Hydrogeological Study
Halton Region
BURLINGTON
LANDFILL SITE
Continued Use

1984
EPA hearing

Project 83-55

GROUND WATER
FLOW
CROSS SECTION B-B'

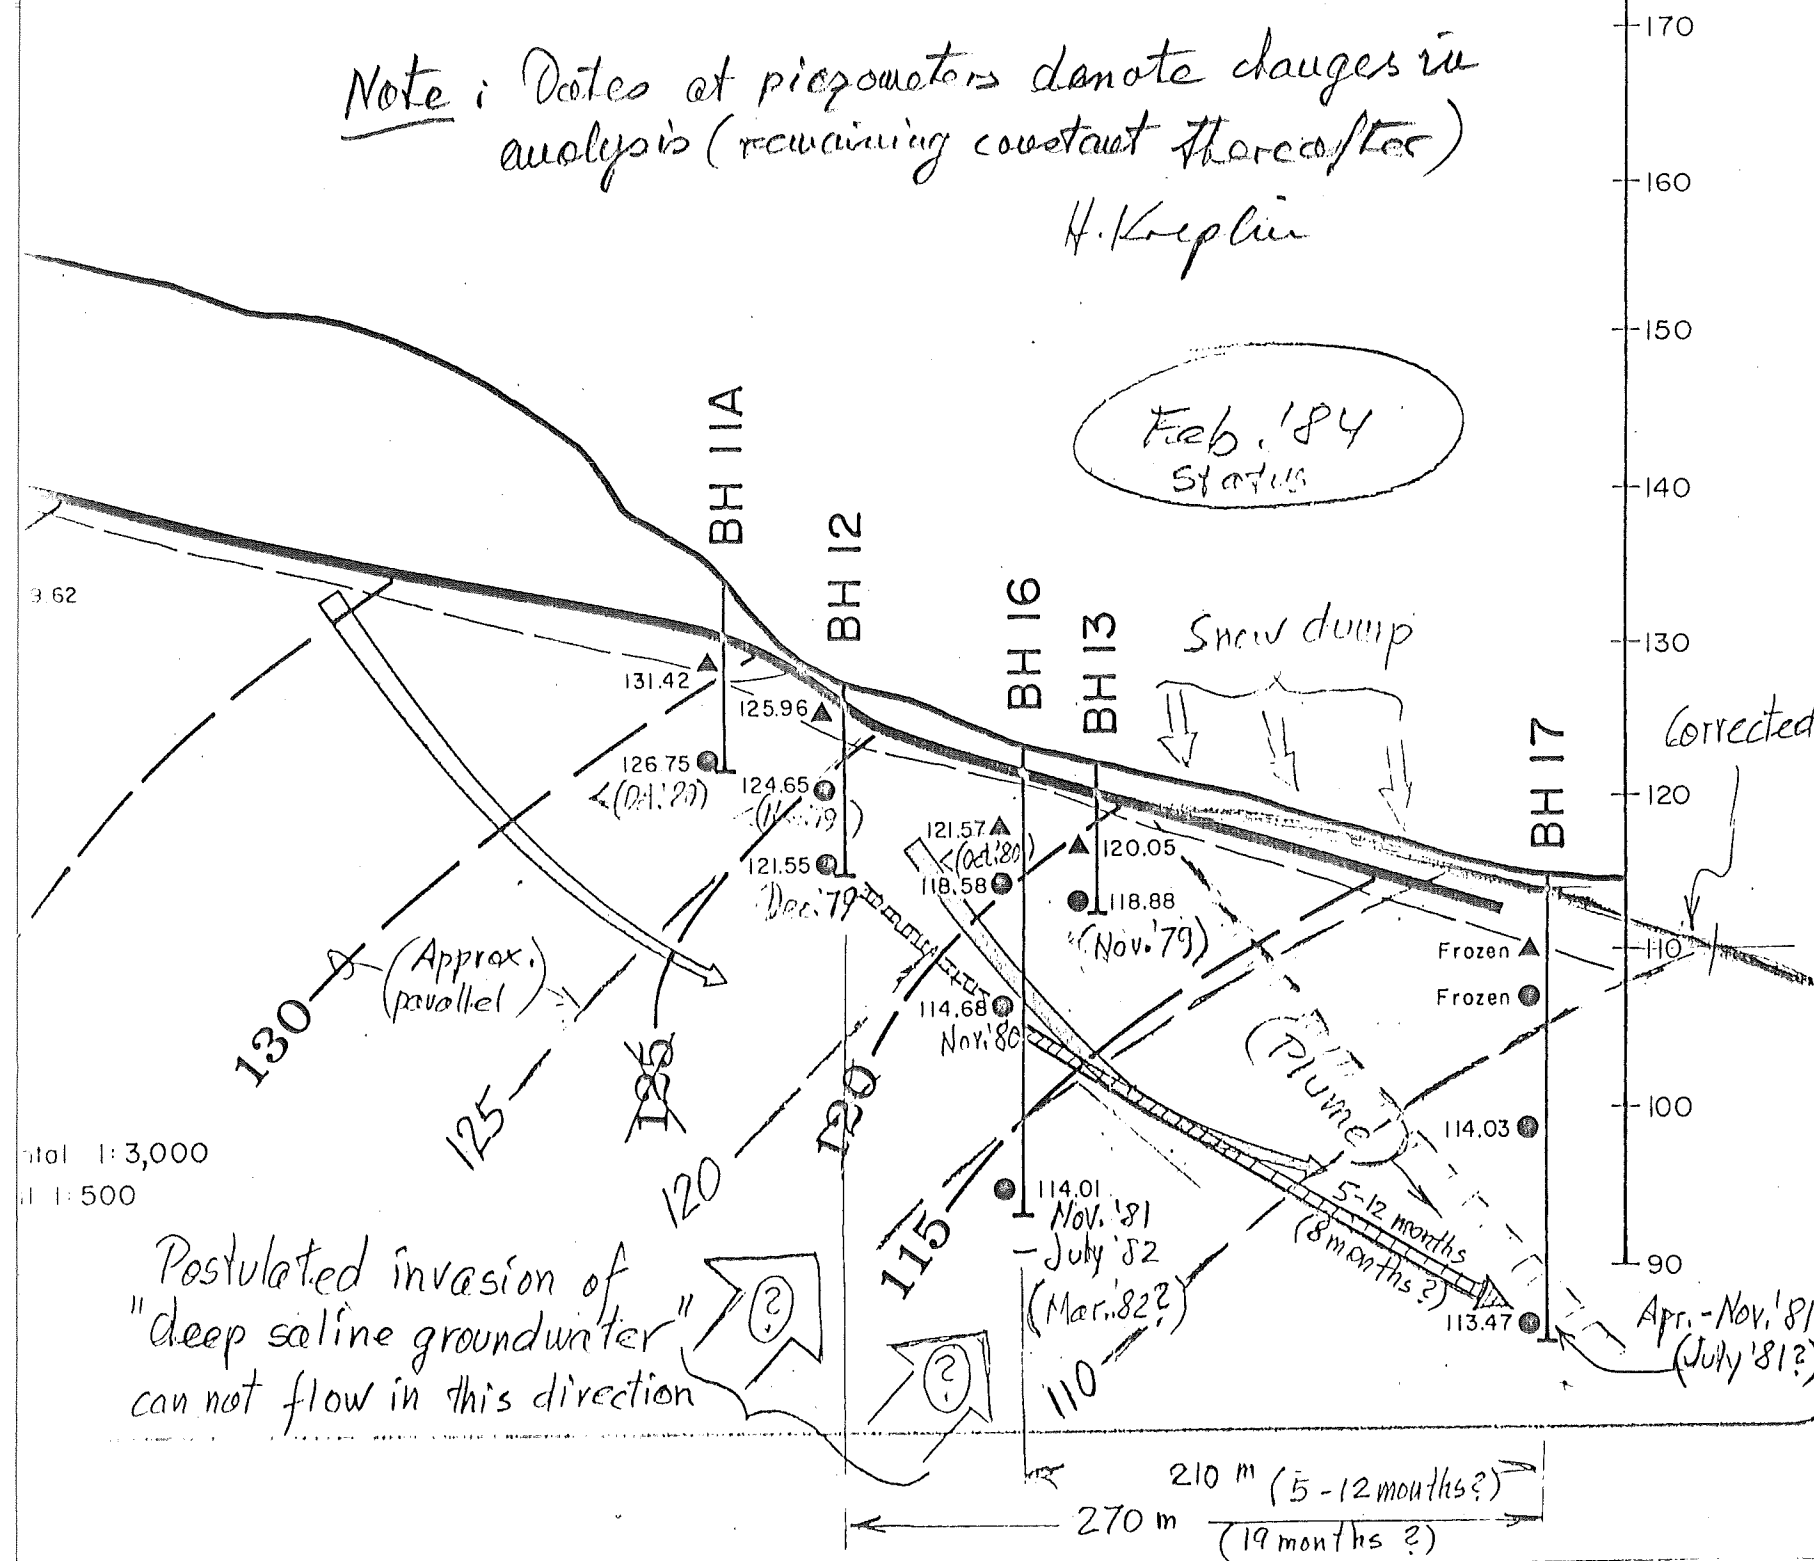
in agreement with the direction of the measured pressure profiles (which are not in question)
